RE: PUC DOCKET # A-2018-3005704
REVISED PLAN – DWG EU00536481

12kV CROSSING OVER	
NORFOLK SOUTHERN RAILROAD COMPANY TRACKS (CROSSING 592203M)	
APPROX. 1268FT NE OF MILEPOST 3	
LOWER ALLEN TWP.	CUMBERLAND CO., PA
APPROVAL K.A. Bowerman	DATE 1/2019
PPL ELECTRIC UTILITIES	
AC	A
CAD ID	FORMAT
DRAWING NO. EU00536481	
SHEET NO. 1	REVISION 1

PLAN AND PROFILE
N SHARE
C SORTS
LOC CODE
LOC CODE
LOC CODE
CU56 PRIMARY LOC CODE

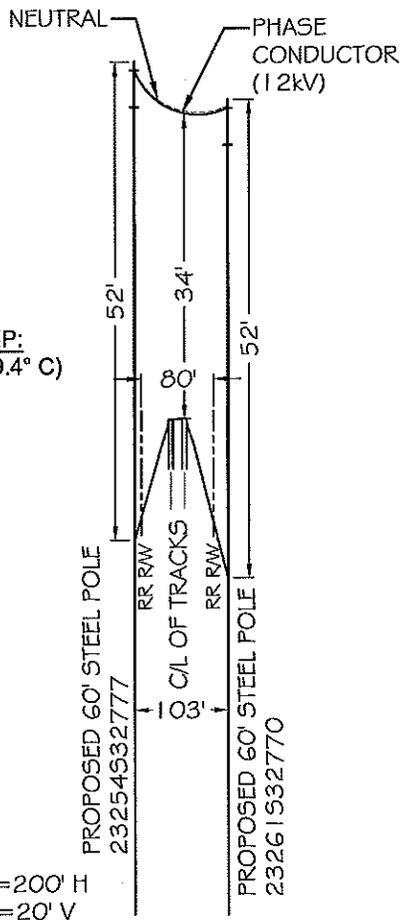
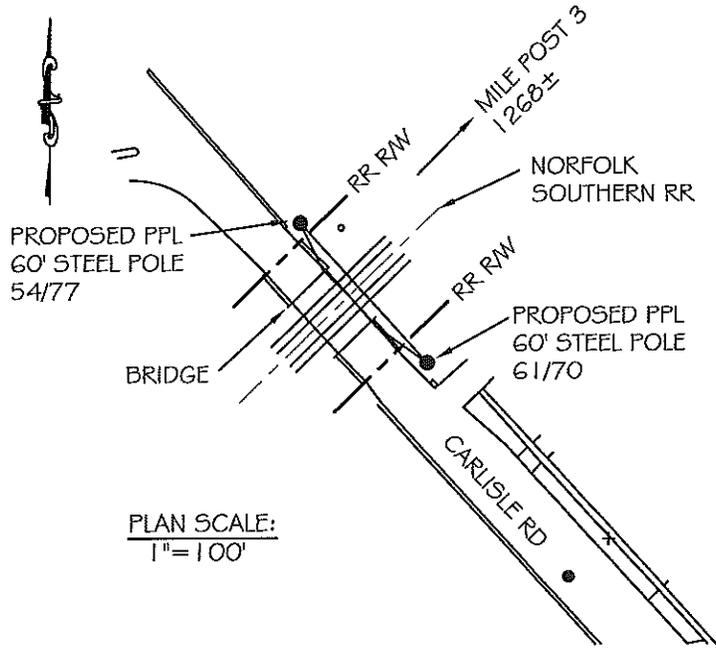
Enclosed you will find a copy of the revised plan [PPL DWG EU00536481]. A revision was necessary to address Norfolk Southern's 12-kV electric power circuit clearance requirement. The plan was revised to have a 34-foot measured sag from the bottom to the top of rail.
